# Recall Bulletin 120813FRV

**PRODUCT(S) AFFECTED:**  
Excursion

**MODEL(S) AFFECTED:**  
33 A

**SUBJECT:**  
Diesel Fuel Intake Line Clearance

Figure 1

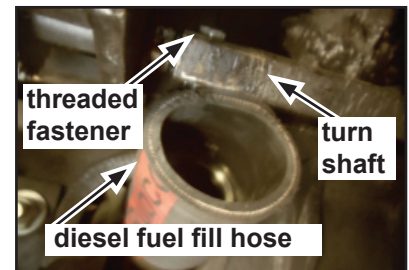
On motor homes affected by this recall, a threaded fastener installed on the turn shaft of the slide-out mechanism may come into contact with a portion of the diesel fuel fill hose while the turn shaft is rotating. If the fastener makes contact with the fuel fill hose, there is a possibility that it will abrade the fuel fill hose and cause a leak. Leaking fuel, in the presence of an ignition source, may lead to a fire.

Follow the steps below to inspect the diesel fuel fill hose, and if necessary, make modifications to eliminate interference between the shaft's threaded fastener and the diesel fuel intake line. Refer to Figure 1 for an example of a fuel line requiring correction.

Figure 2

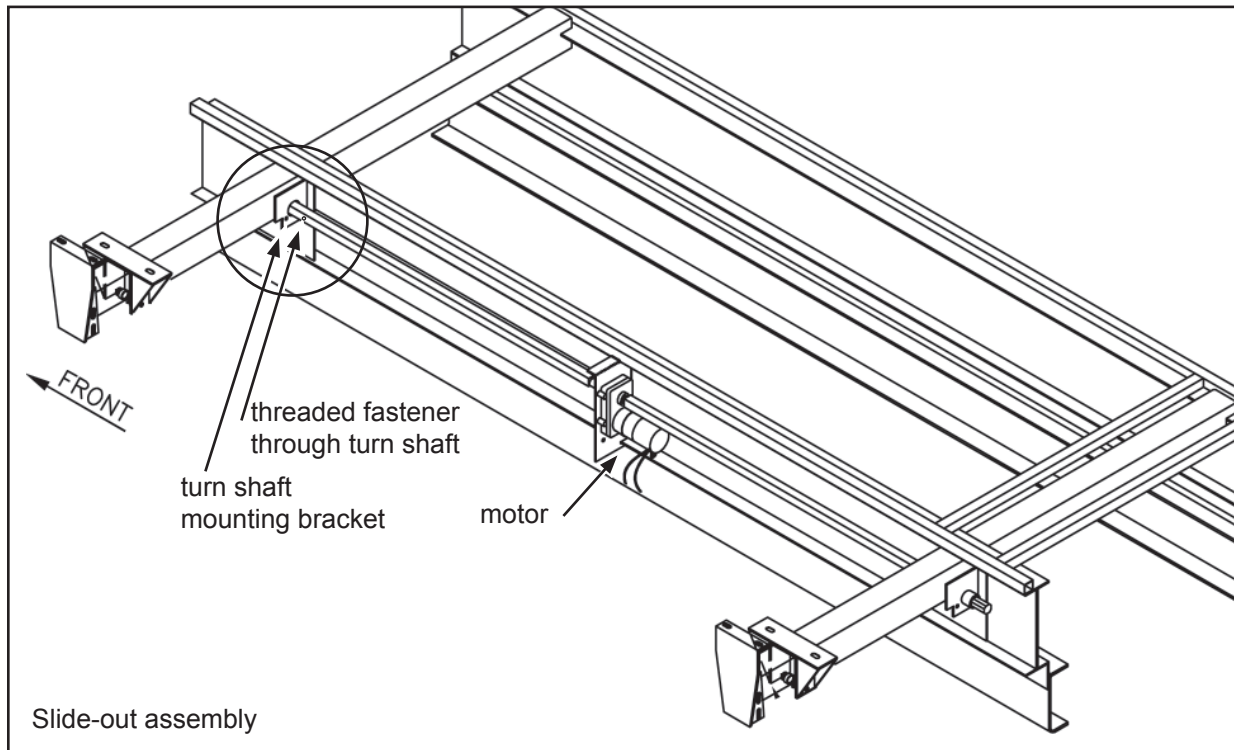
3. Have an assistant bump the control for the slide-out room, extending it just enough that the turn shaft rotates a full 360°. From under the motor home, observe the turn shaft as it rotates, inspecting for any interference between the shaft's threaded fastener and the diesel fuel intake line. Refer to the circled area in the diagram in Figure 2 for the approximate location of the fastener.

- If the threaded fastener does not make any contact with the diesel fuel intake line, no further action is required.
  - If the threaded fastener contacts any portion of the diesel fuel intake line, determine whether or not the threaded end of the fastener can be shortened to eliminate contact with the fuel line.

- Proceed to Step 4 if the threaded fastener can be shortened to eliminate contact with the fuel fill line.
    - If damage to the diesel fuel intake line is found, or if shortening the fastener will not eliminate contact with the fuel line, contact Fleetwood RV Dealer Technical Support for further instructions and Prior Authorization to perform additional or alternate repairs.

4. Use a cut-off wheel or Dremel tool to cut off the threads of the fastener that extend past the nut. **Do not cut or damage the nut.**
5. Inspect the shaft again as the assistant operates the room.
